THE GLEN AT WIDEFIELD FILING NO. 12
RESIDENTIAL SUBDIVISION CONSTRUCTION DRAWINGS
PREPARED FOR WIDEFIELD INVESTMENT GROUP

EPC STORMWATER REVIEW COMMENTS
IN ORANGE BOXES WITH BLACK TEXT

Kiowa Project No. 19016
May 3rd, 2023

GLEN AT WIDEFIELD NO. 12
Plan and Profile - Ground Cherry Trail
Sta: 1+00 to END
EL PASO, COUNTY, COLORADO

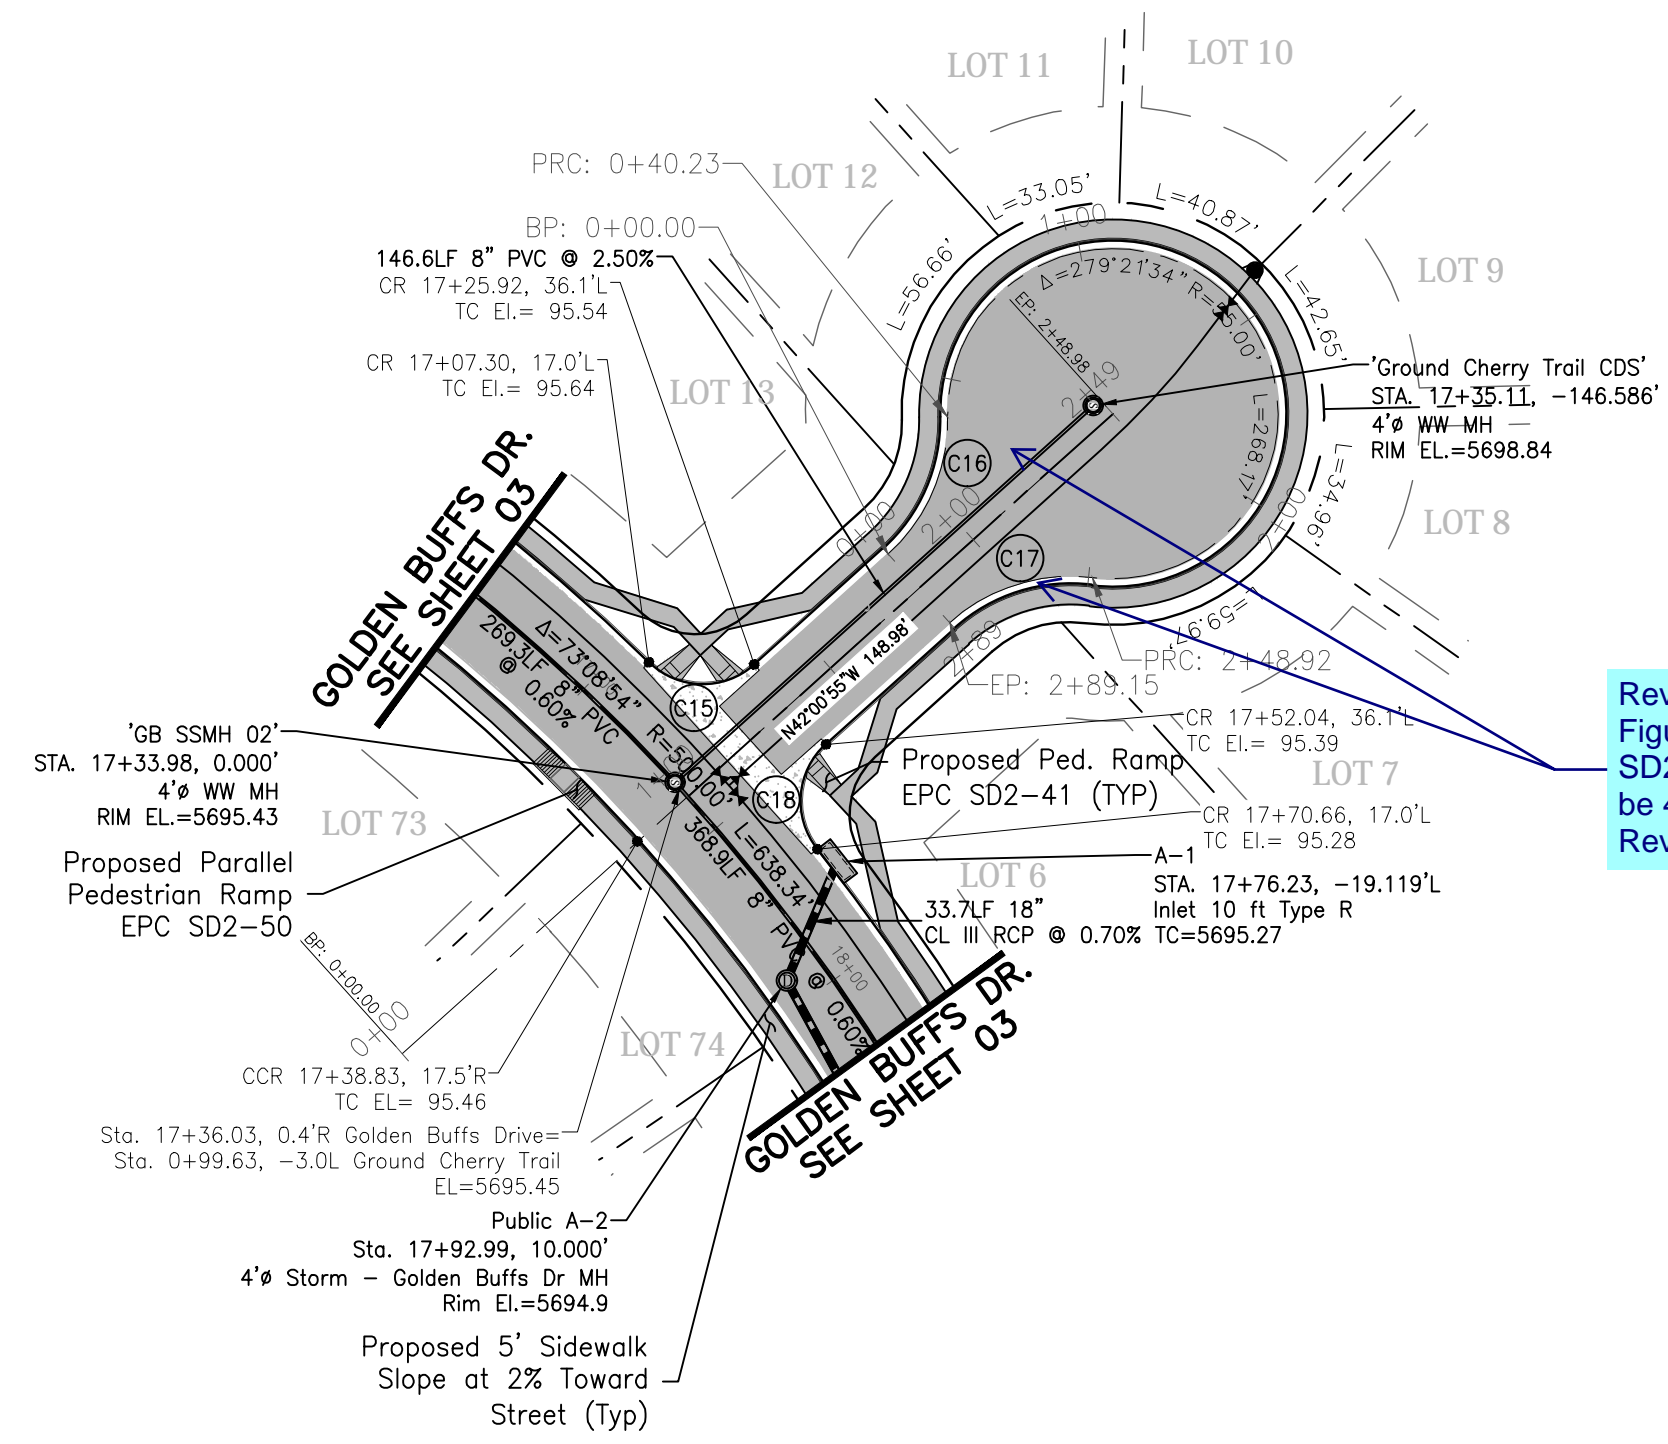
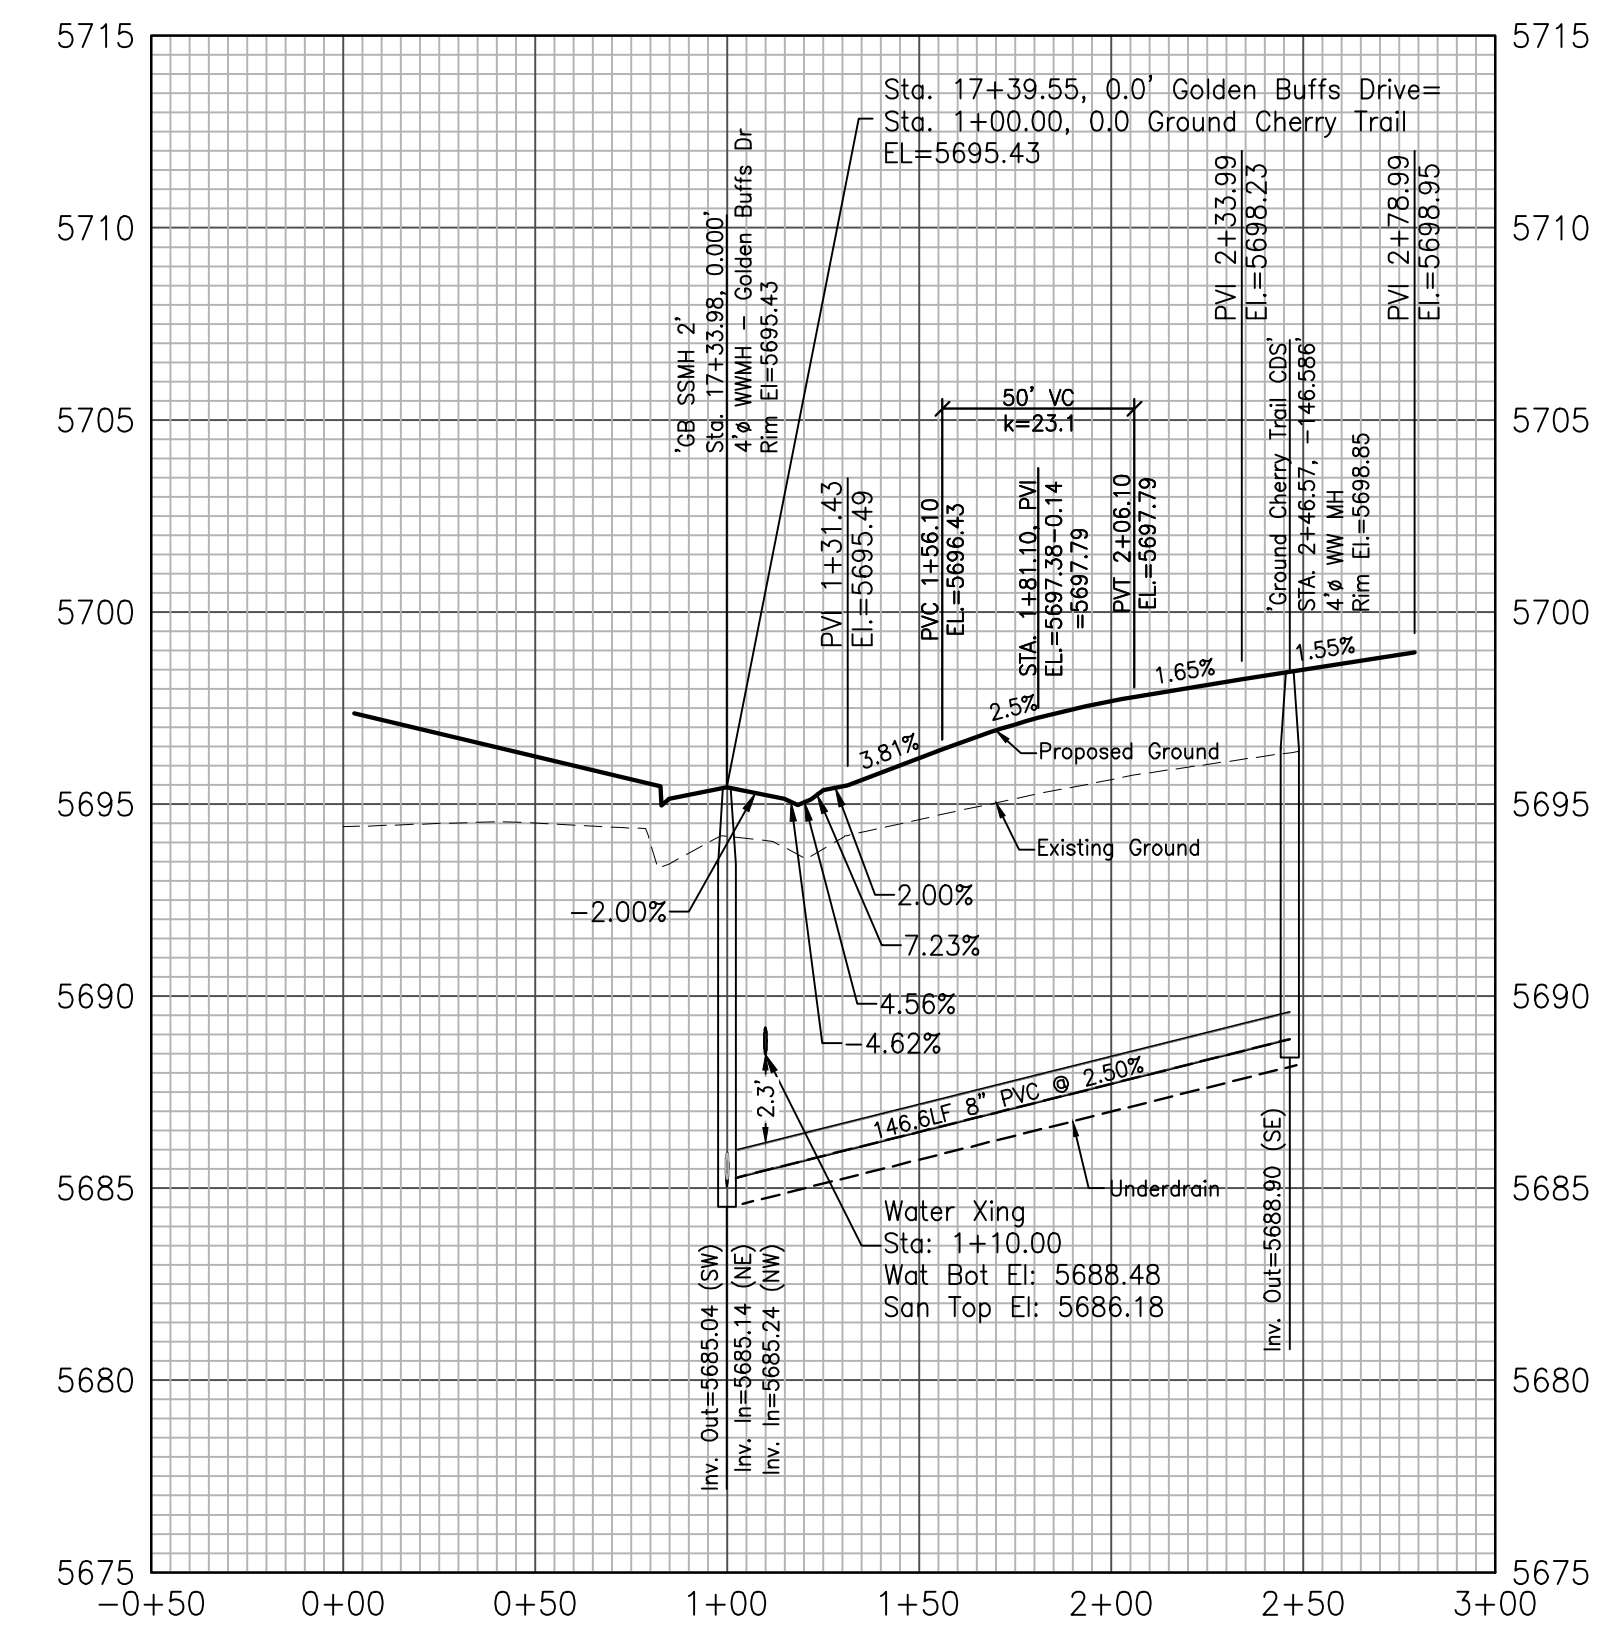
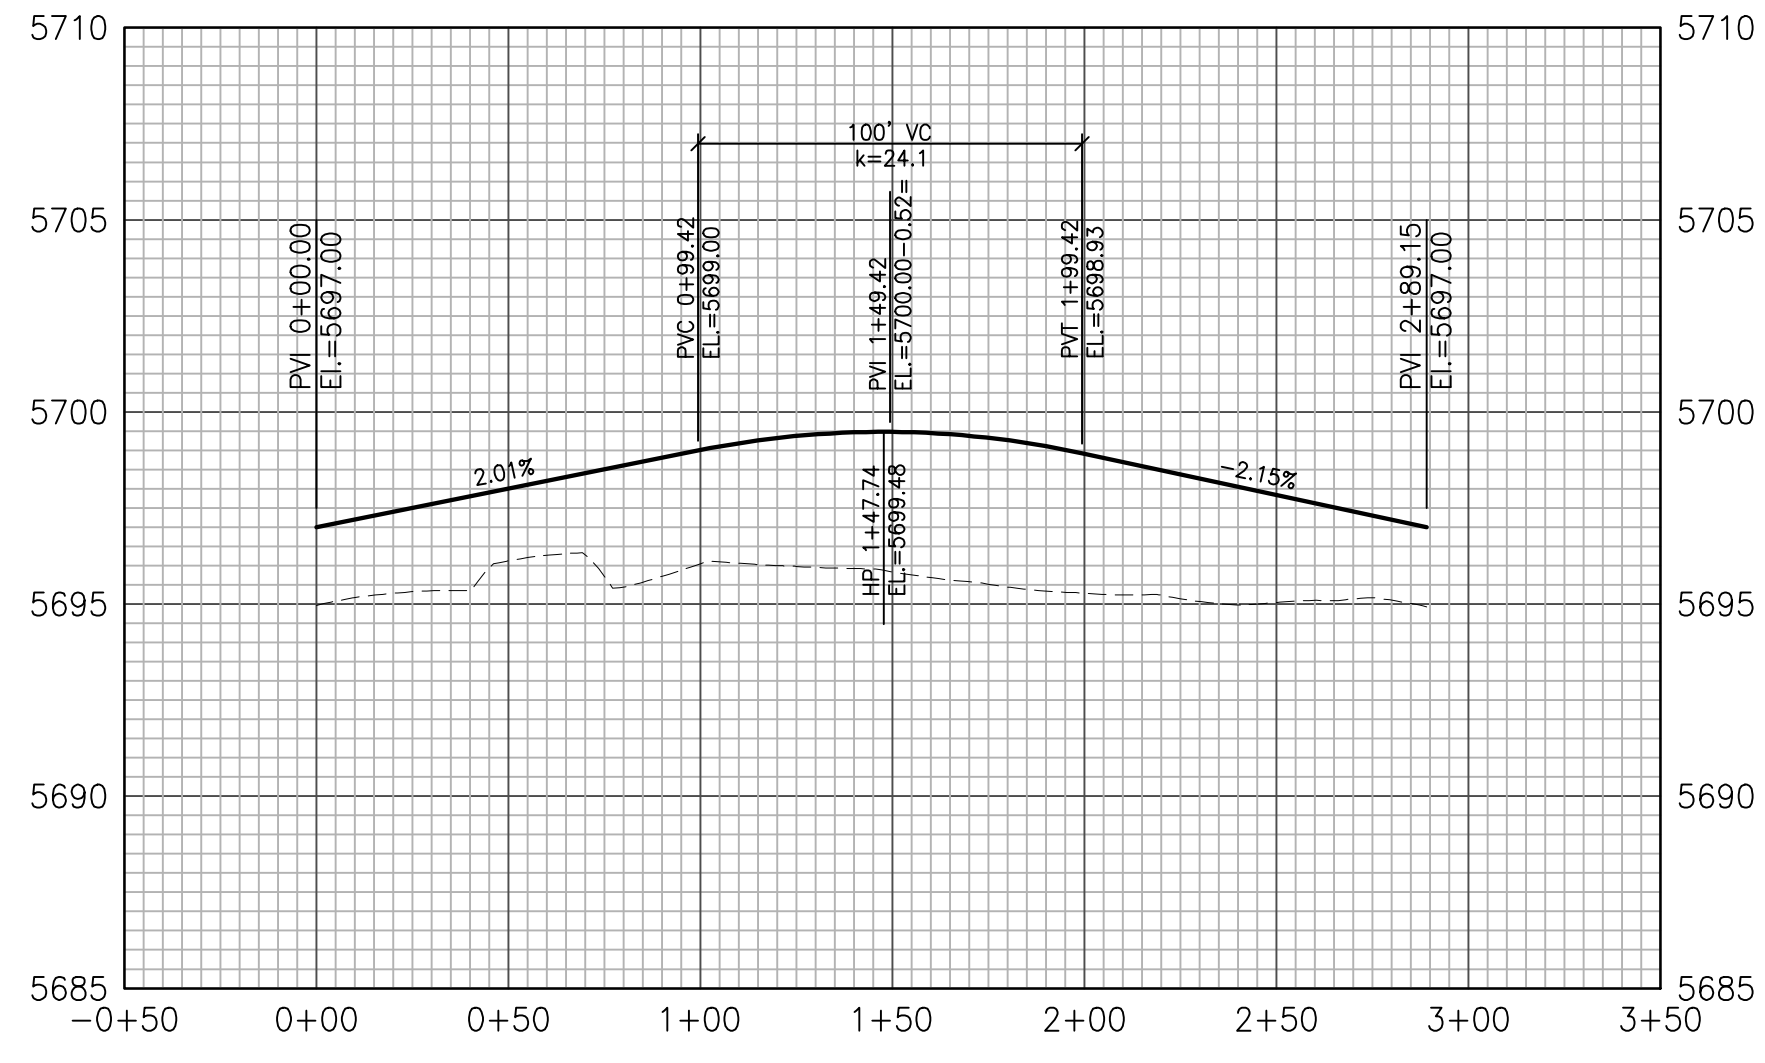
Review 2: Per ECM Figure 2-31 and detail SD2-75 radius shall be 45'. Please revise.
Review 3: Unresolved
